**NOTICE OF ZONING ACTION**

LEGAL: Lots 4A, 5A and 7A, Tract A, Anchorage Village Subdivision, S.M., Anchorage Recording District, Anchorage, Alaska. Generally located south of West 100th Avenue, east of C Street, north of West 104th Avenue and west of King Street.  
PETITIONER: 100<sup>th</sup> & C Pads, LLC  
REQUEST: Administrative review of an Amendment to an existing Site Plan Review for a large retail development per AMC 21.50.320.  
ATTACHMENT: Copy of the Municipality of Anchorage, Planning Division Letter of Approval dated October 7, 2015

**SUBJECT:** Case 2015-0097 Administrative Review of an Amendment to an Approved Site Plan for a Large Retail Establishment (Case 2007-101)

C STREET  
 ADOT CONTROLLED ACCESS LINE

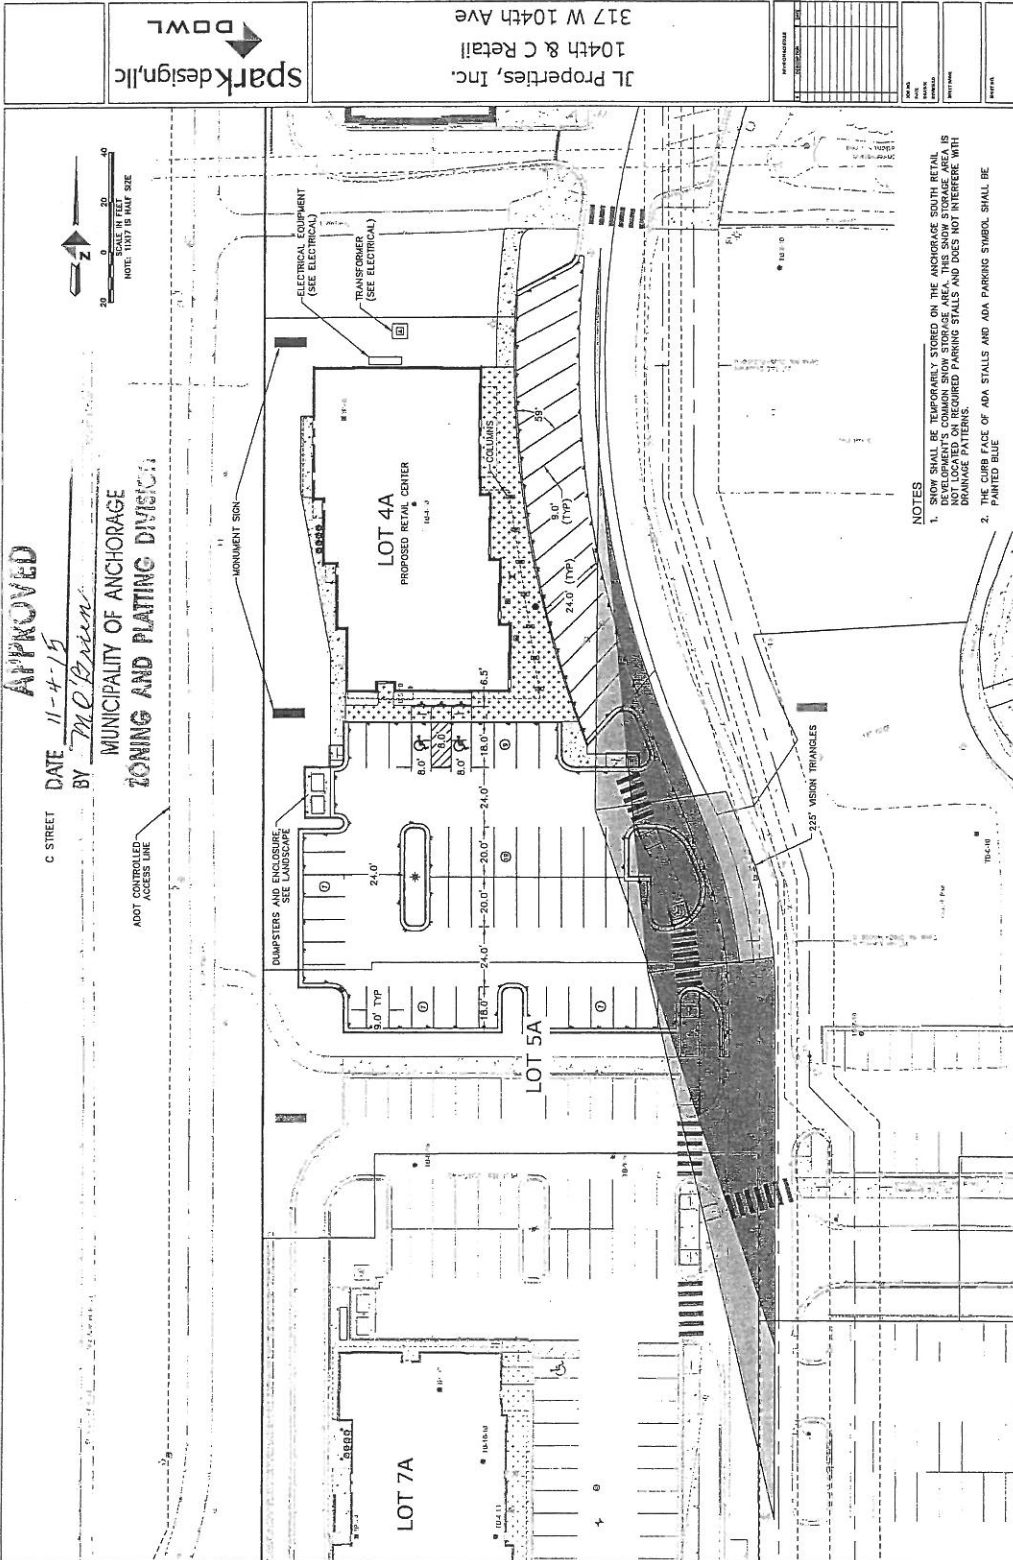
Verify that the pedestrian access is not crossing the controlled access line.

1. Please consider Fragment Lot 7. The functional area of the southerly driveway near the West 104<sup>th</sup> intersection does not appear to have adequate corner clearance.

2. Please show the AASHTO sight distance triangles at the proposed points of ingress/egress for these lots.

3. Provide revised site and landscape plans (Sheets L1 – L4, at a minimum 11" x 17") that show the following:
  - a. AASHTO sight distance triangles at the proposed points of ingress/egress for these lots.

- b. The delivery and loading berth(s) on the site plan for Fragment Lots 4A and 7A.
  - c. Temporary snow storage areas on the landscape plans.
4. Provide revised elevation drawings (at a minimum 11"x 17") showing compliance with AMC 21.50.320P.1. for the street-facing elevations.

**NOTES**  
 1. SNOW SHALL BE TEMPORARILY STORED ON THE ANCHORAGE SOUTH RETAIL DEVELOPMENT'S COMMON SNOW STORAGE AREA. THIS SNOW STORAGE AREA IS TO BE USED FOR TEMPORARILY STORED PARKING STALLS AND DOES NOT INTERFERE WITH DRAINAGE PATTERNS.  
 2. THE CURB FACE OF ADA STALLS AND ADA PARKING SYMBOL SHALL BE PAINTED BLUE
